CABINET MEMBER FOR ENVIRONMENT – 29 JUNE 2017

PROPOSED 30MPH SPEED LIMIT FOXCOMBE ROAD SUNNINGWELL AND WOOTTON

Report by Strategic Director, Communities

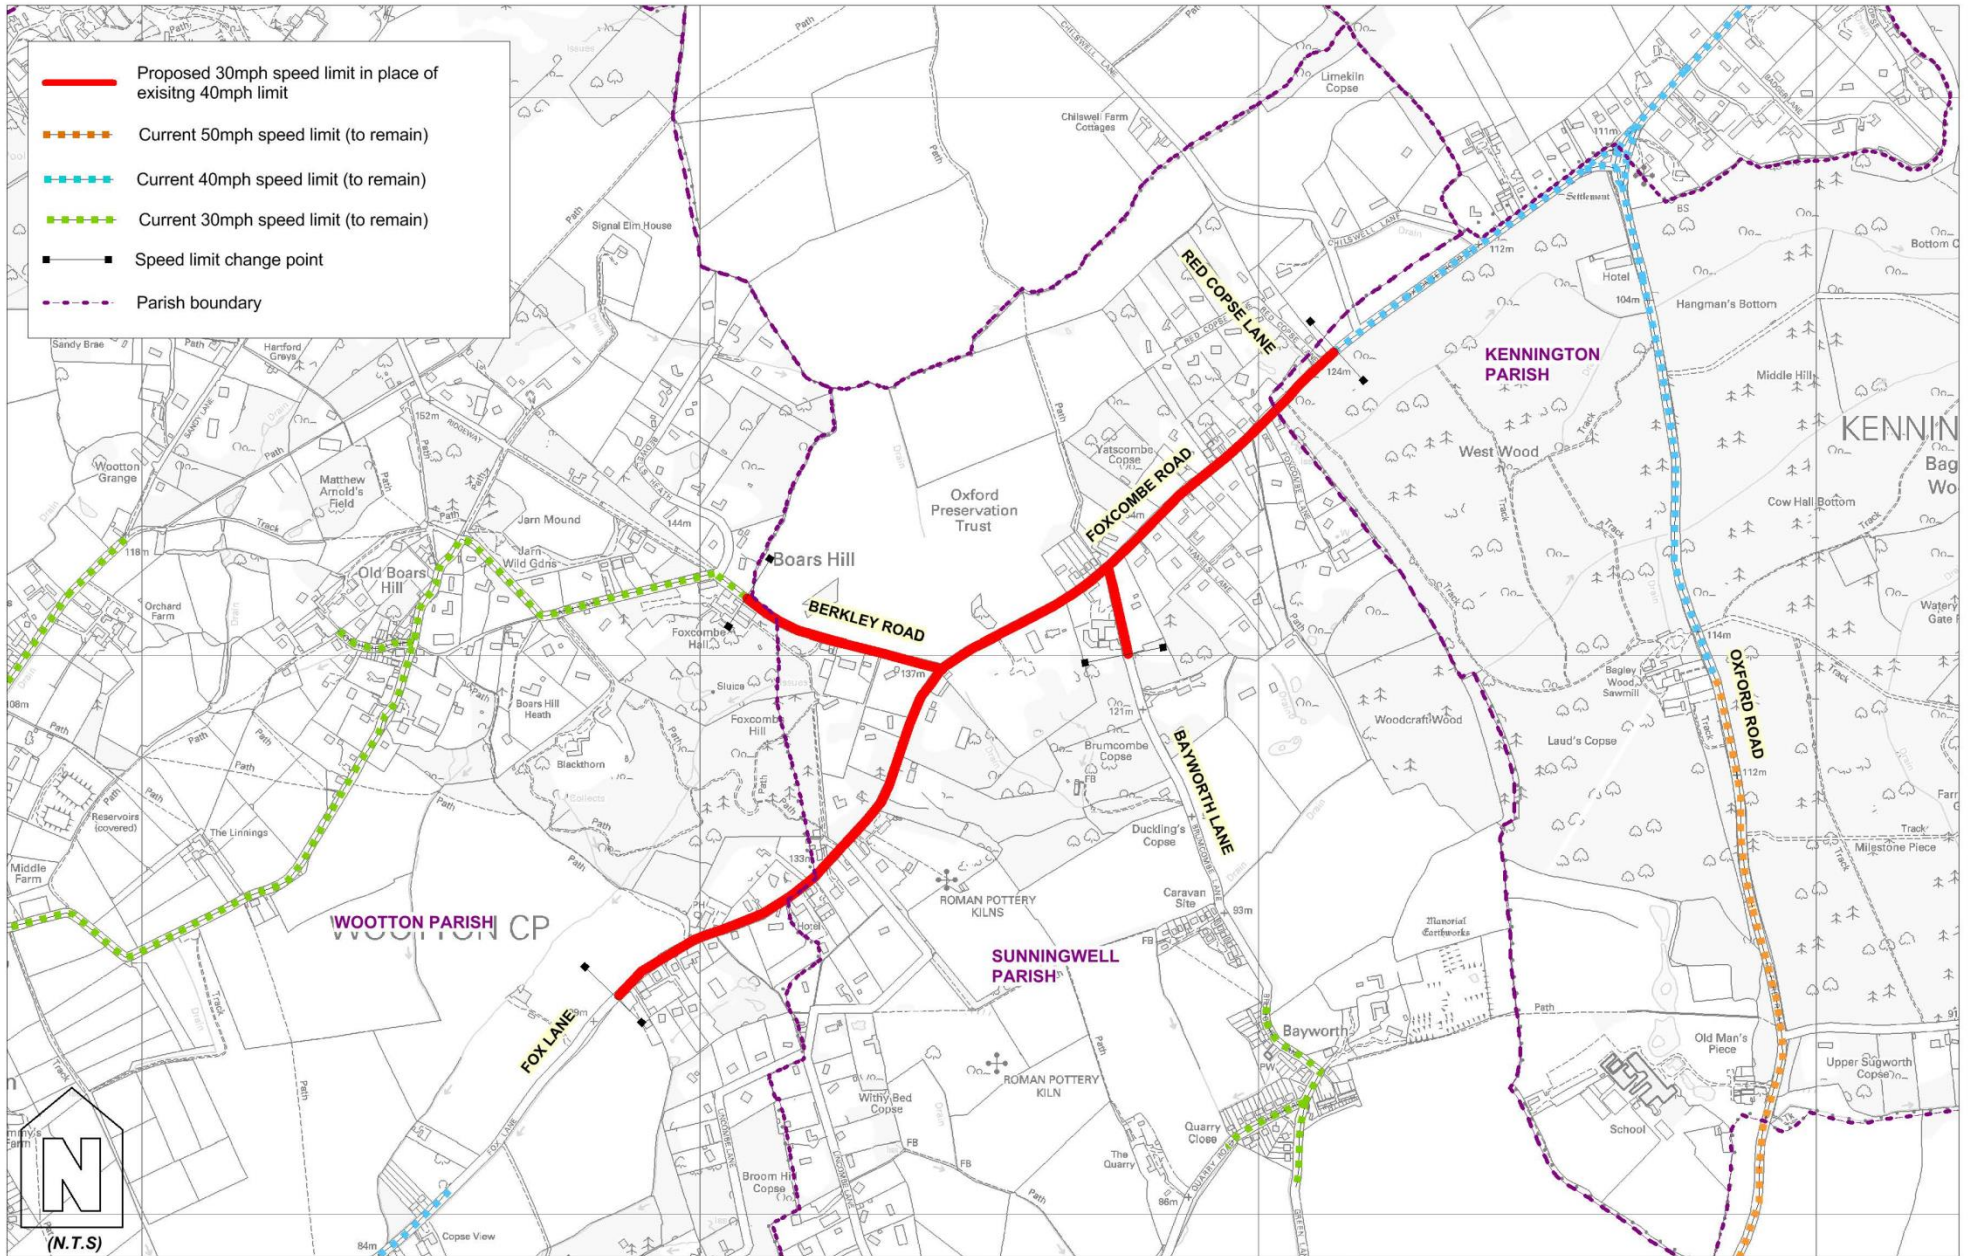
5. Thames Valley Police objected to the proposal on the grounds that taking account of the character of the road, the limited reported accident history, and the observed speeds, the current 40mph speed limit was appropriate and that the proposed 30mph speed limit would be unrealistically low.

6. An elected member of the Vale of White Horse District Council representing this area also objected, on the grounds that if the proposal was approved, the speed limit changes on Fox Lane, Foxcombe Road and Hinksey Hill would be confusing, with (starting from the junction of Fox Lane) with the B4017 Lamborough Hill) a 40mph limit, a short section of national speed limit, then the 30mph speed limit as currently proposed, with then a 40mph limit through to the junction of Hinksey Hill with the A34/A423 Hinksey Hill interchange. The view was expressed that a 30mph speed limit on the entire route would be best, or alternatively a 40mph limit.

7. Officers from the Vale of the White Horse District Council planning department have not objected.
8. Two responses were received from members of the public supporting the proposed 30mph speed limit, but also requesting that this should be extended to the north east to include the remainder of Foxcombe Road to its junction with Hinksey Hill, and also Hinksey Hill, to its junction with the A34/A423 Hinksey Hill interchange, noting that there were a significant number of residential properties with accesses onto the road.

RESPONDENT	SUMMARISED COMMENTS
(1) Thames Valley Police	Object – having taken into account: collision history, speed of existing traffic, road environment, enforcement, road character and driver perception etc.

(2) Vale of White Horse District Councillor	Object - support a consistent speed limit over the boundary between Boars Hill and Hinksey Hill. 30mph would be best, but 40mph everywhere is better than 40mph, national speed limit, the proposed 30mph speed limit and then 40mph again as one drives towards Hinksey Hill.

(3) Vale of White Horse District Council Planning	No objection.
(4) Online response	Support - It would seem sensible to have a 30mph limit right from the top of Boars Hill and all the way down Hinksey Hill (the latter at present being 40mph). This would be more consistent than leaving the Hinksey Hill stretch at 40mph. Could this be added in? I suspect that traffic surveys have been done on Hinksey Hill in the not too recent past when the 40mph was adopted.

(5) Online response	Support - Please consider making all of Hinksey Hill (from the roundabout to Foxcombe lane) 30mph too. This is a residential area and children and elderly residents frequently cross the road to use the bus stops etc. Cars using it as a cut through off the ring road regularly drive at high speed along this road, and traffic calming measures and/or a reduced speed limit would greatly enhance the safety of the residents of this road.

9. The response of Thames Valley Police is noted, and it is accepted that the current traffic speeds (which will to a significant extent reflect the perceptions of drivers as to the character of the road) are arguably more consistent with the 40mph speed limit than the proposed 30mph limit, and also that the reported accident history is modest, with only one slight injury accident recorded in the latest 5-years for which such data is available.

10. The response from the member of the Vale of the White Horse District Council is also noted, and it is also accepted that multiple changes in speed limit on a route can be confusing for drivers.

11. The expressions of support from two members of the public for the proposal but also requesting that the 30mph speed limit should also apply to the A34/A423 Hinksey Hill interchange are noted, and it is agreed that there are a significant number of residential premises adjacent to the length of Foxcombe Road east of the proposed 30mph speed limit, and on Hinksey Hill.

16. Sunningwell Parish Council have been made fully aware of the above, and given that the proposal if approved would be funded by the council, and that the majority of the length of the proposed 30mph limit does nevertheless technically comply with DfT guidance, there would appear to be a case for its approval, notwithstanding the police objection, or the objection of the local Vale of the White Horse District councillor, noting that the proposal would result in a further speed limit change, but also that in respect of the request for a continuous 30mph speed limit, this would clearly not comply with the DfT guidance.

17. Should the proposal be approved, it is recommended that further speed surveys are carried out to assess its effect not only on the length where the speed limit is reduced, but also on the length of Foxcombe Road to the north east of the proposed change, and also Hinksey Hill, noting that in informal discussions with members of South Hinksey Parish Council (who are supportive of the proposal but have also asked for it to be extended to the Hinksey Hill interchange), some concerns were raised that drivers may increase speeds on these roads, having travelled at a lower speed on the 30mph section.

- 21. **The Cabinet Member for the Environment is RECOMMENDED to approve the proposal as advertised**
